ADDENDUM NO. 2

Life Sciences Collaboration
 1910 N. Antelope Valley
 Parkway
 Lincoln, Nebraska
 TCEP No.: 716-002-12
 Davis Design.: 12-0077
 BVH No.: L12018.unl
 November 27, 2013

Third Floor Plumbing Plan

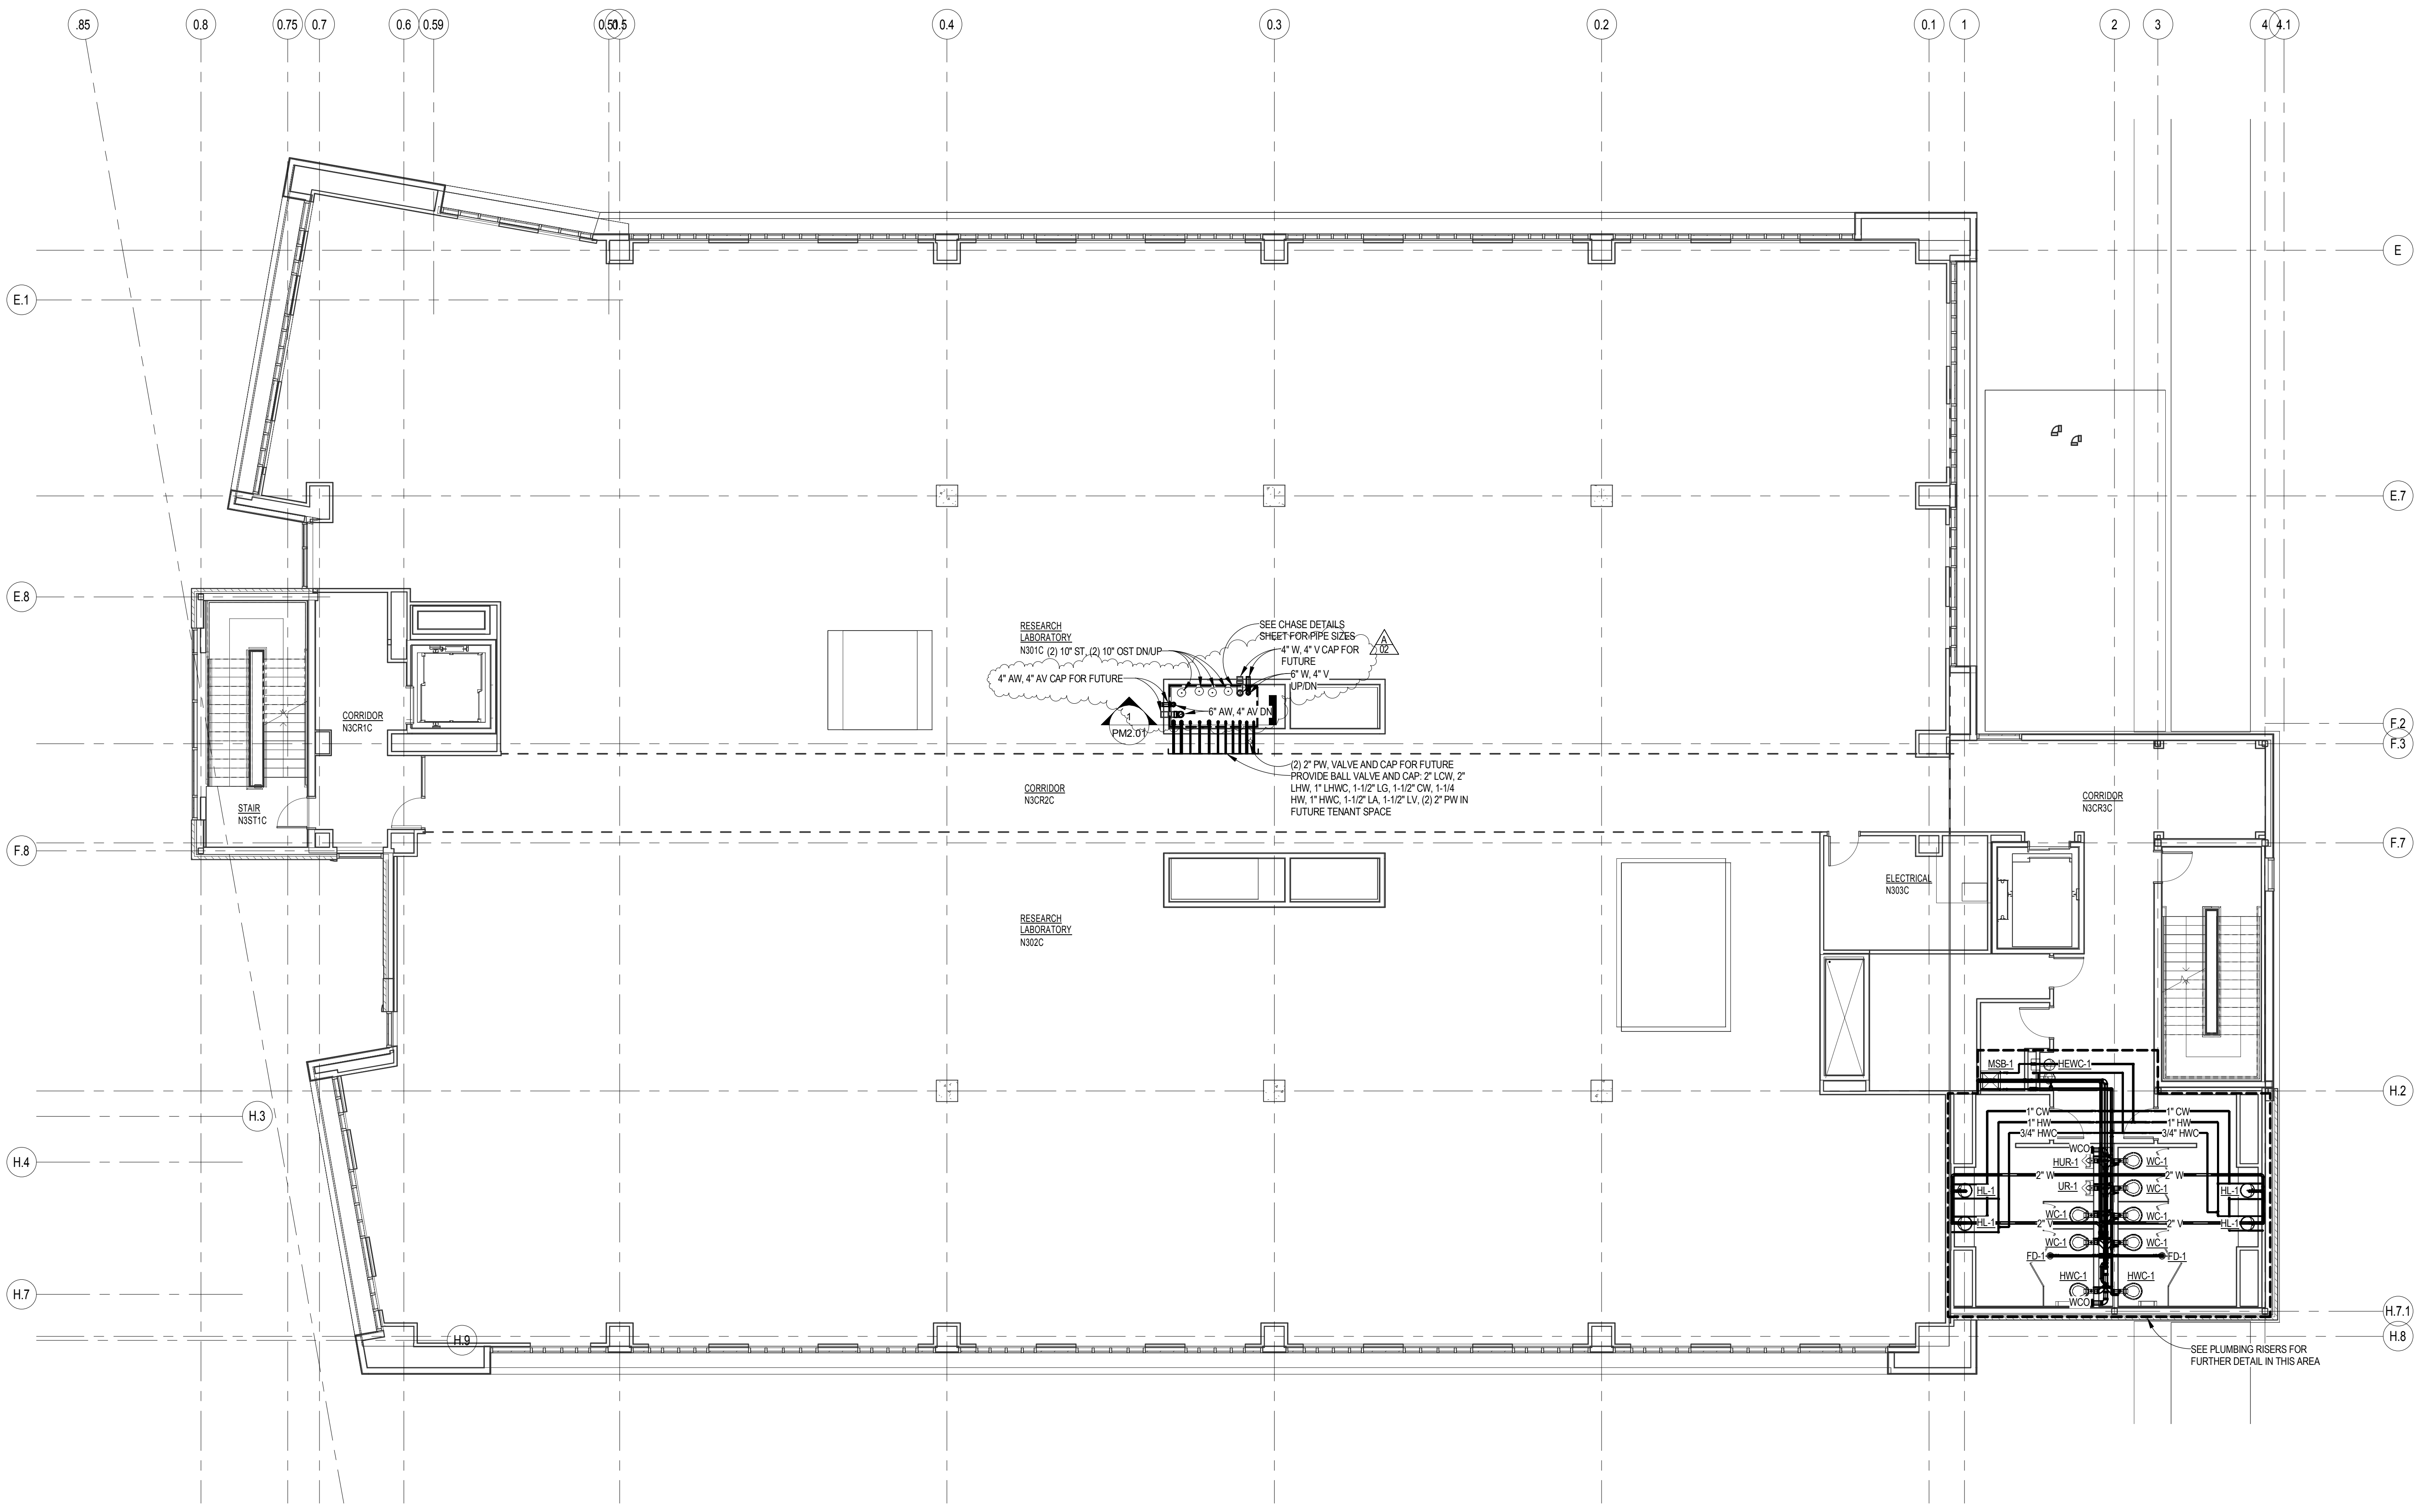
Item 2-66: P1.13 – Third Floor Plumbing Plan

See reissued sheet for added 4" V and 4" AV mains and stub-outs in the central plumbing chase.

Fourth Floor Plumbing
Plan

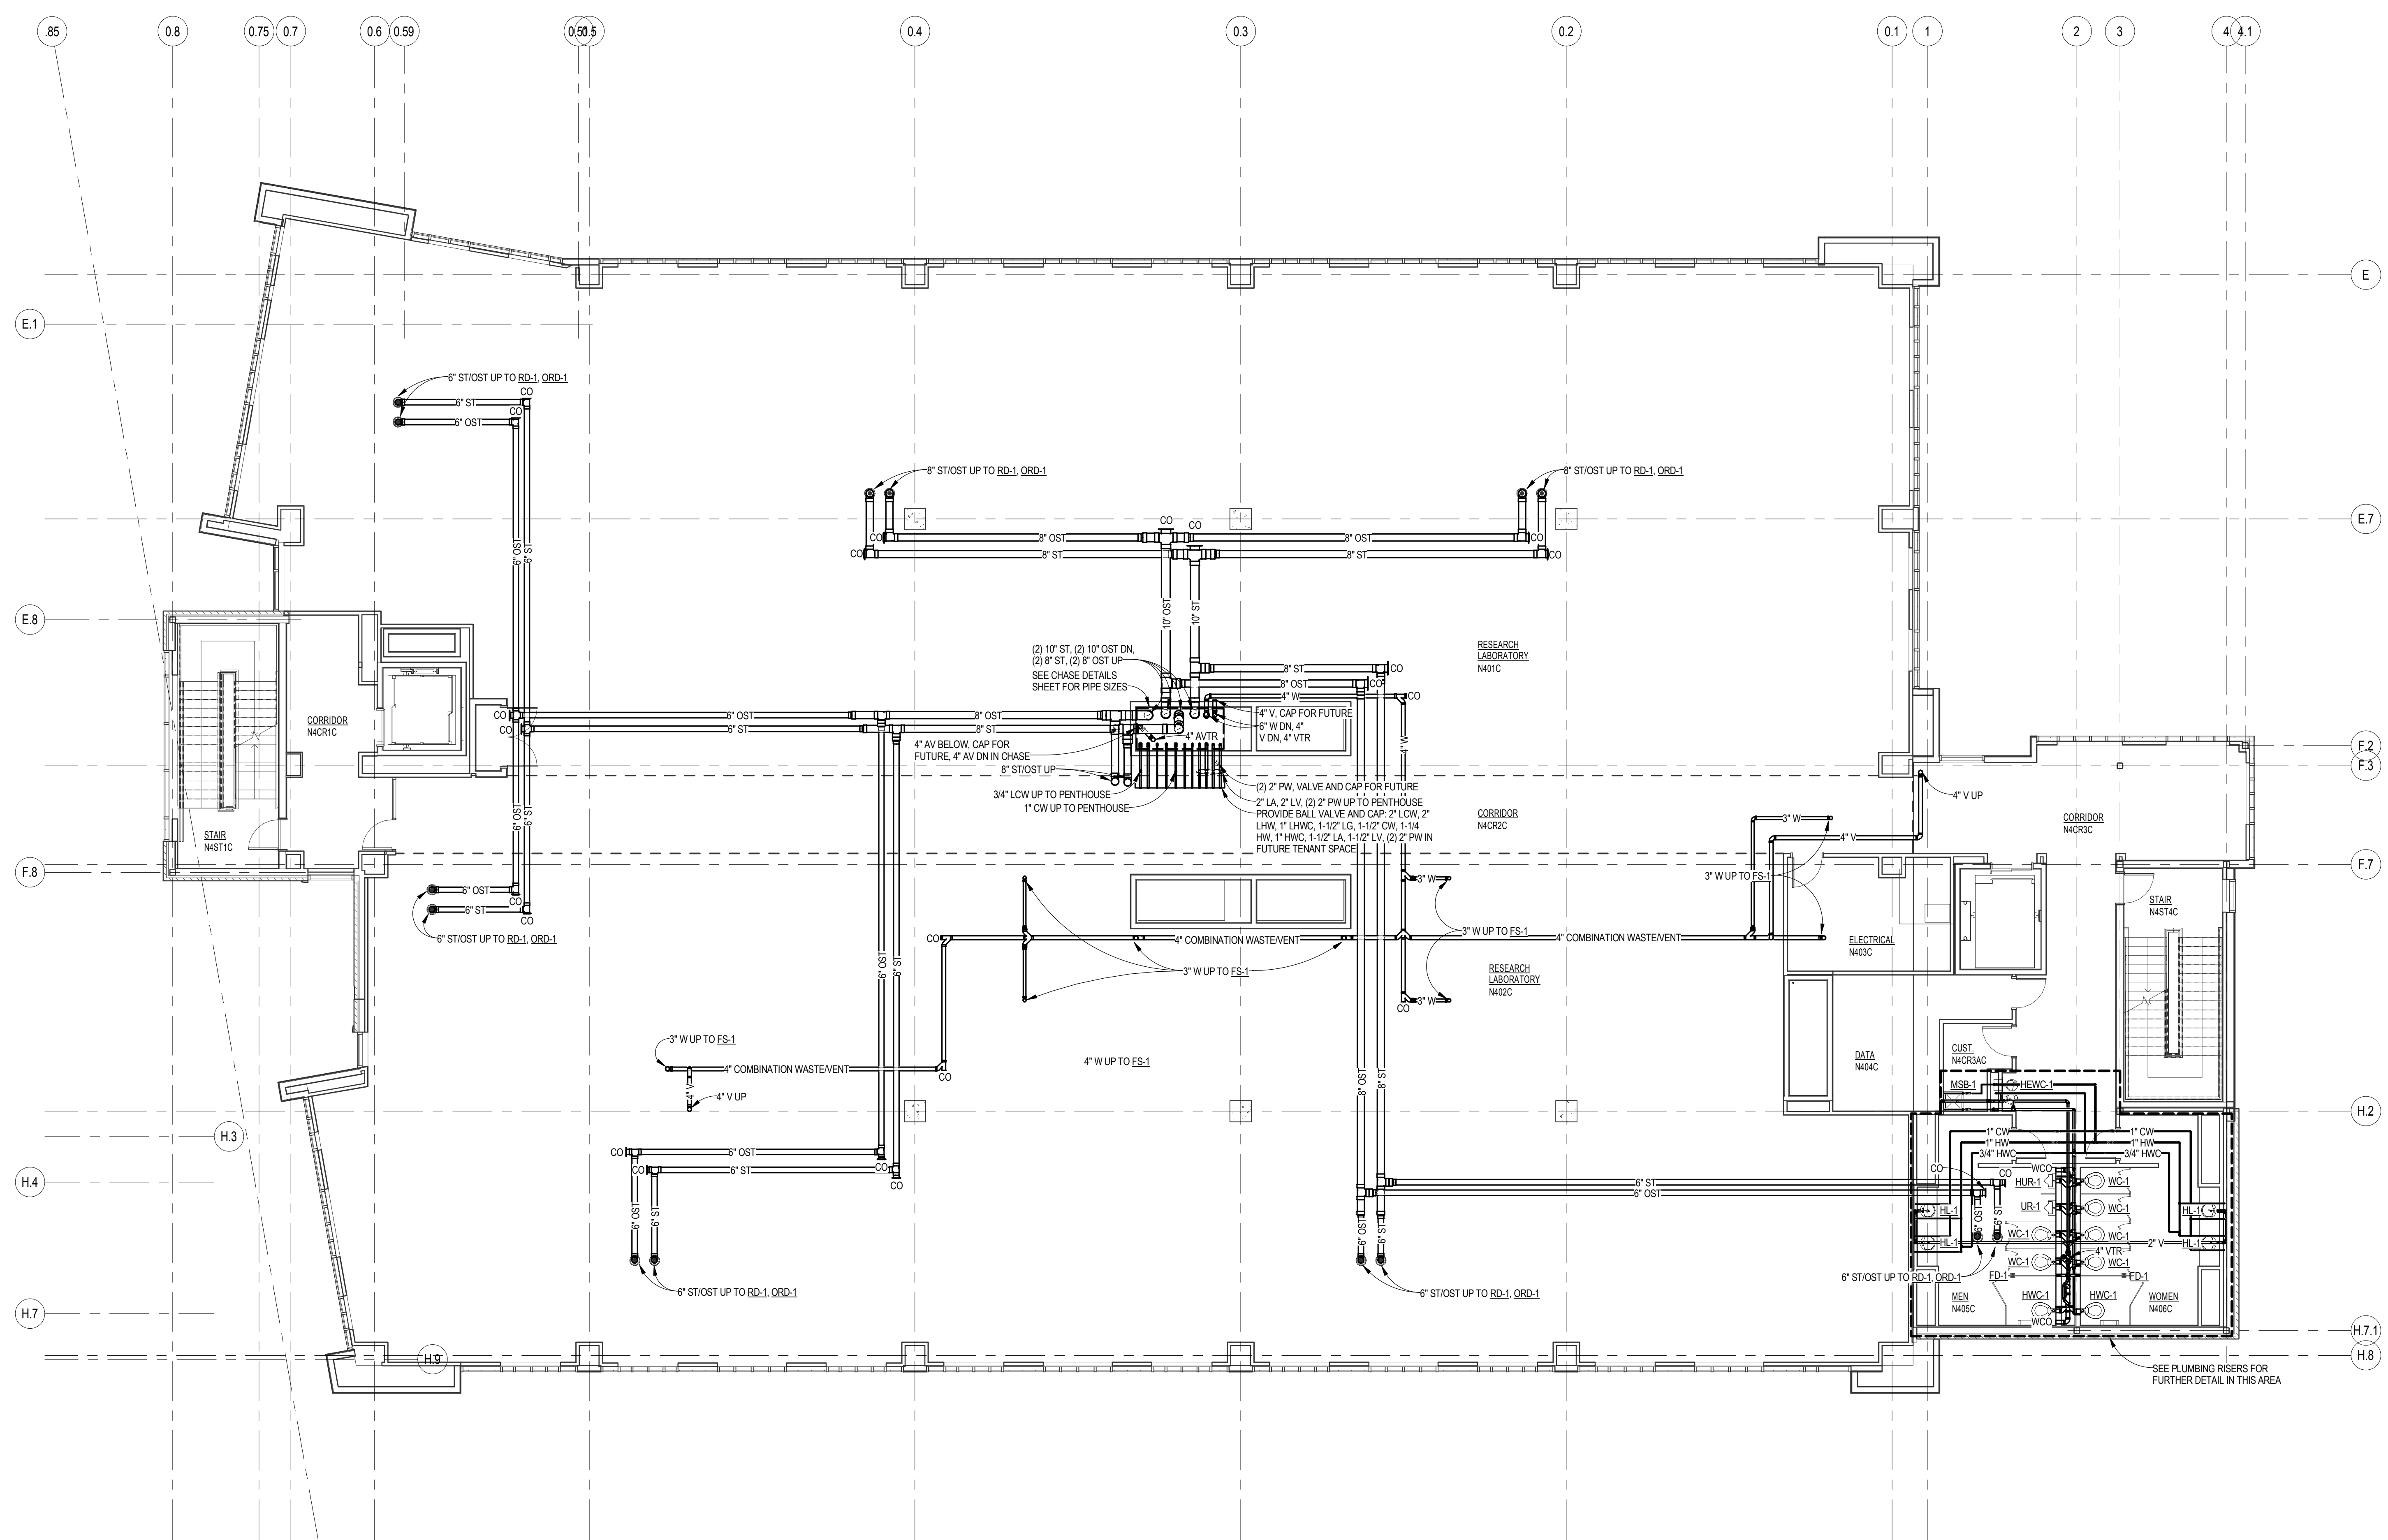
Item 2-67: P1.14 – Fourth Floor Plumbing Plan

See reissued sheet for revised roof drain and storm piping sizing and routing. See central plumbing chase for added 4" V and 4" AV mains and stub-outs.

Mechanical Roof Plan

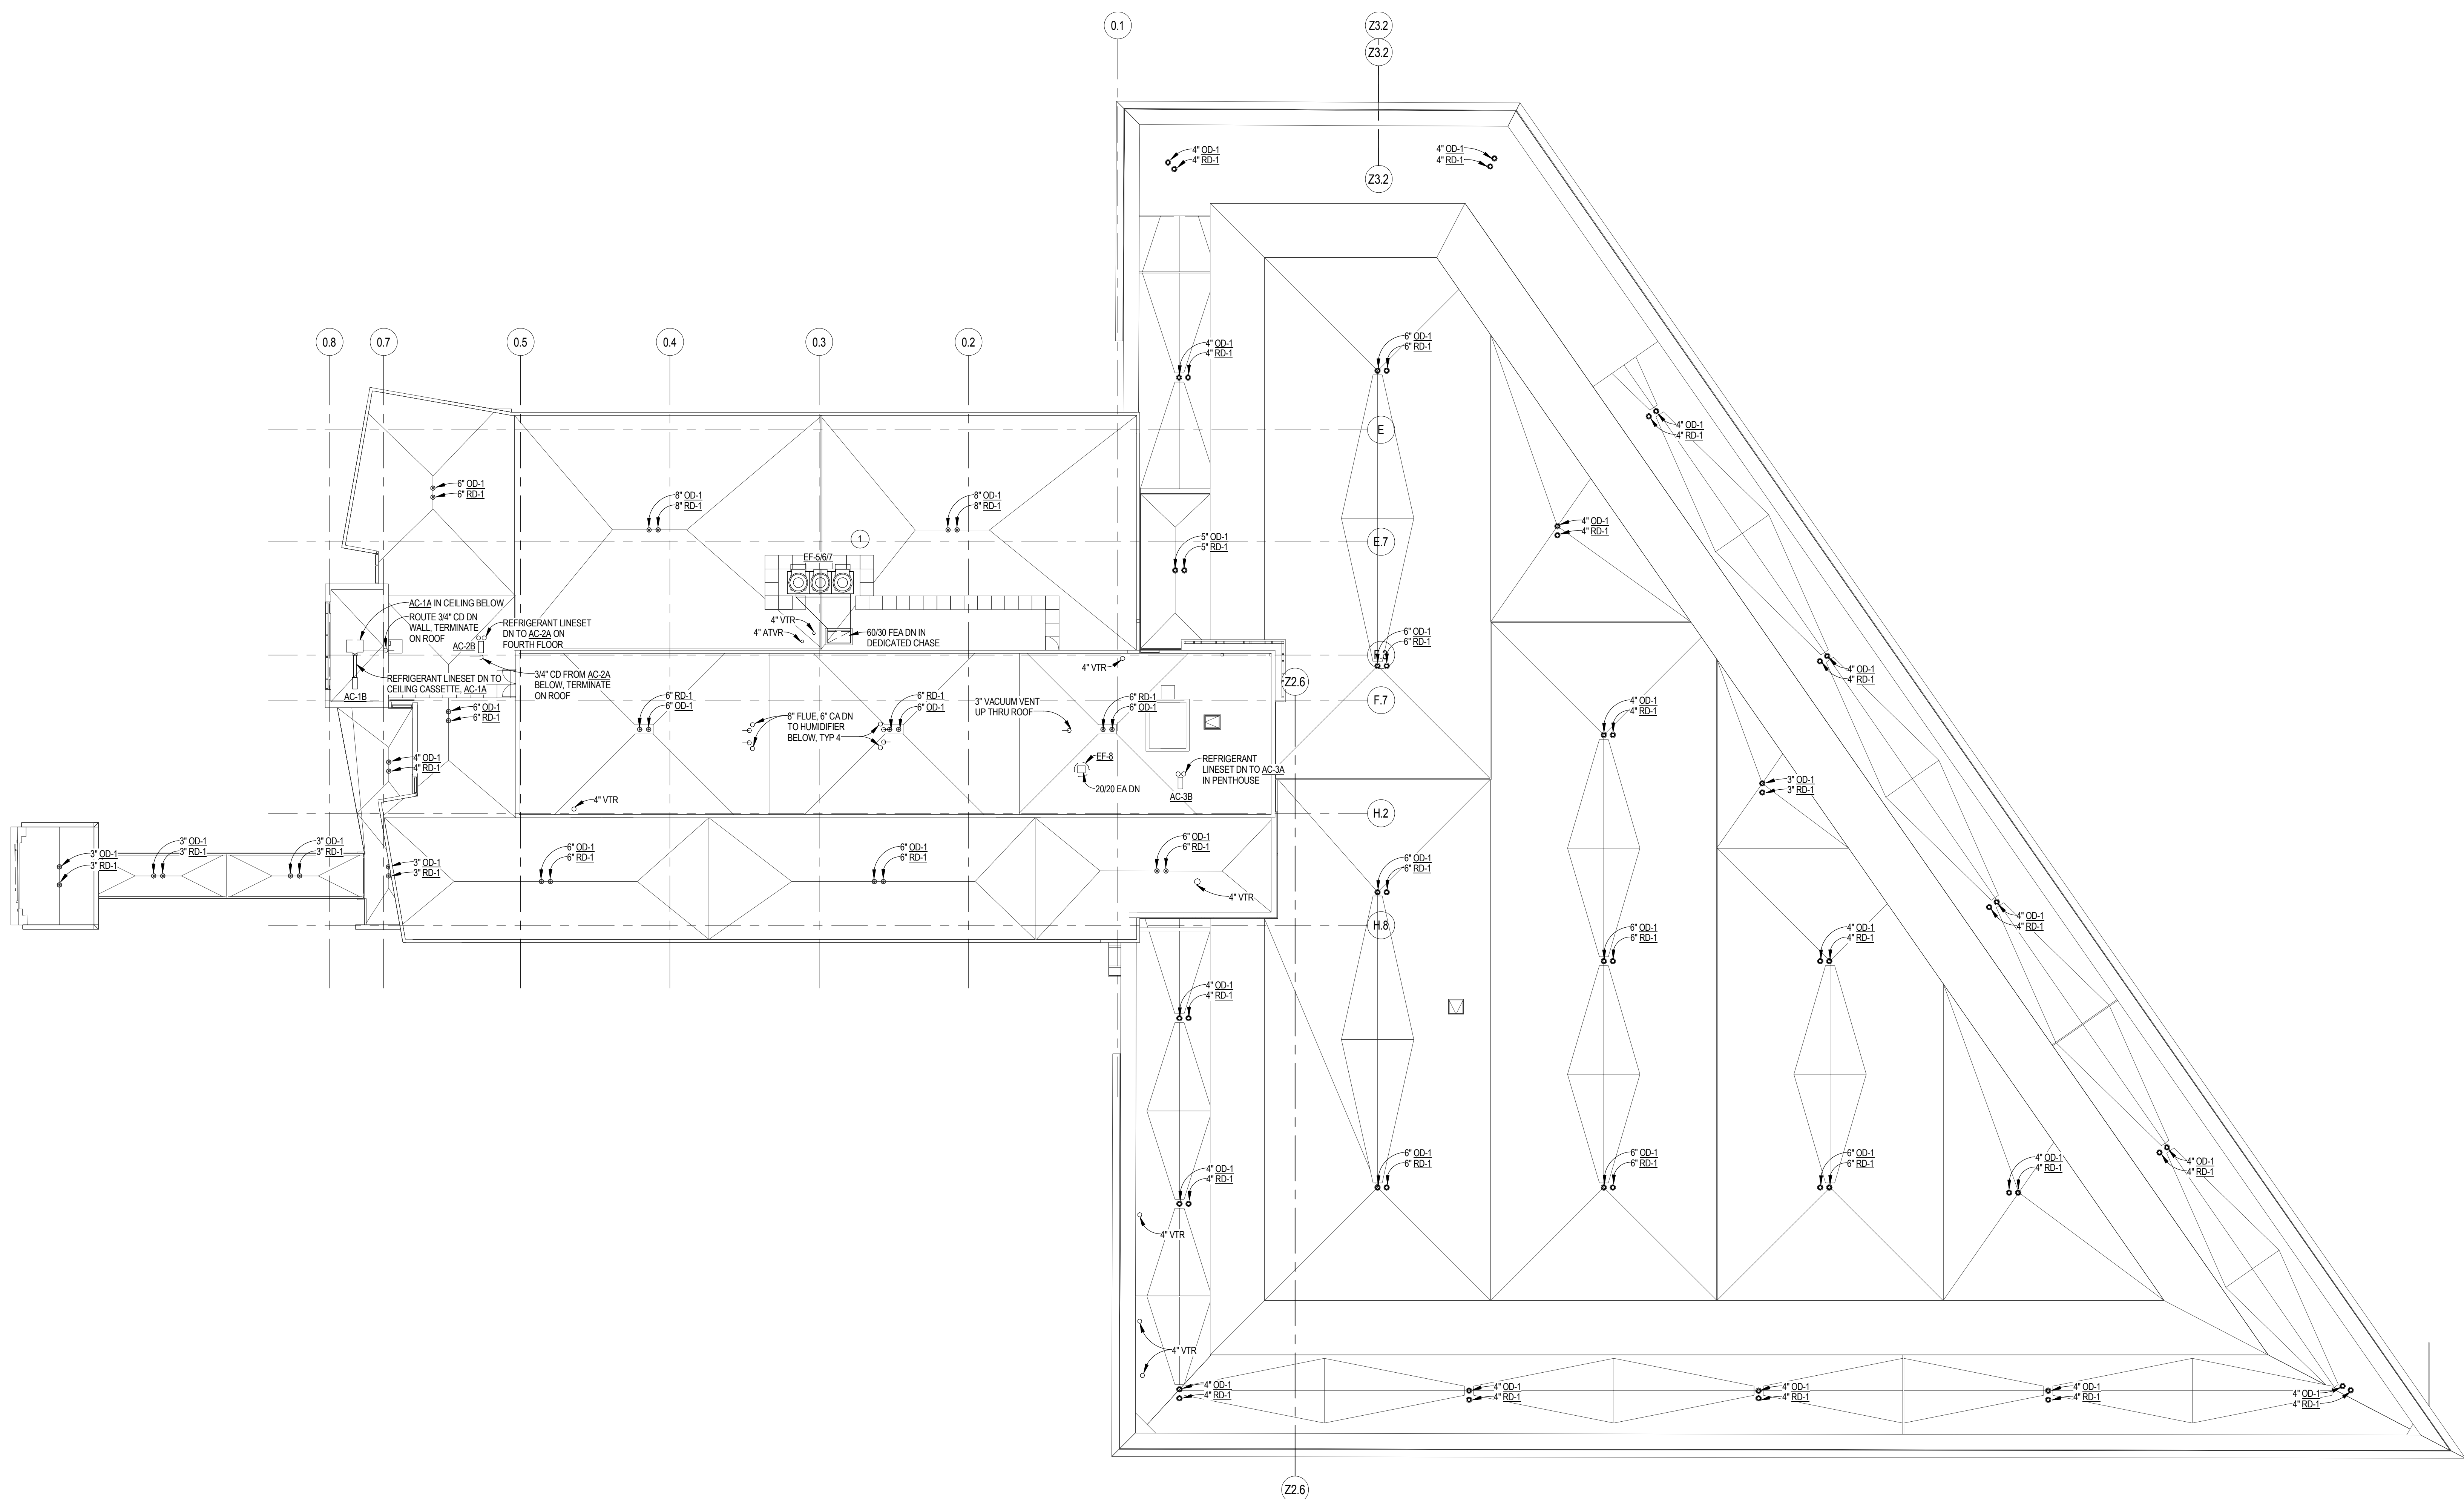
Item 2-55: PM1.05 – Mechanical Roof Plan

See reissued sheet for revised roof drain sizing and 4" VTR and 4" AVTR above central plumbing chase.
